FEDERAL COMMUNICATIONS COMMISSION 445 12th Street, S.W. WASHINGTON DC 20554

> In re: K235BU, Charleston Park, NV BPFT-20090826ABQ Facility ID No. 156220

This letter refers to the above-captioned application for K235BU, Charleston Park, Nevada.

THE FOLLOWING IS A LIST OF THE DATA WHICH APPEARS ON THE ABOVE MAP

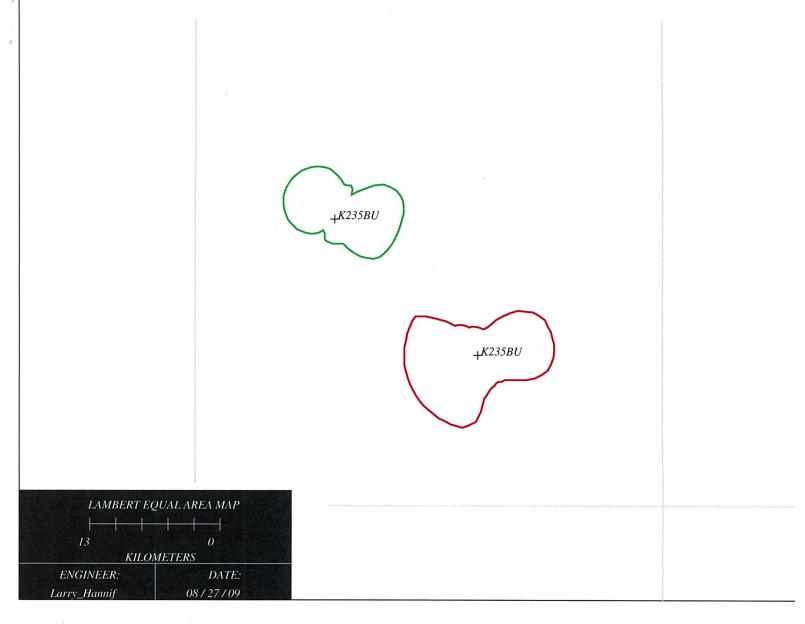
An engineering study reveals the application is a major change pursuant to Section 74.1233(a)(1) of the Commission's Rules. Specifically, the proposed 60 dBu service area fails to provide service to some portion of its 60 dBu licensed service area, (BLFT-20090727ADW). Therefore, the proposal is a major change. Because major change applications are not being accepted for filing, the application will be dismissed.

In light of the above, the application BPFT-20090826ABQ filed by Ondas De Vida Network, Inc. is unacceptable for filing pursuant to 47 C.F.R. § 73.3566(a) and IS HEREBY DISMISSED. This action is taken pursuant to 47 C.F.R. § 0.283.
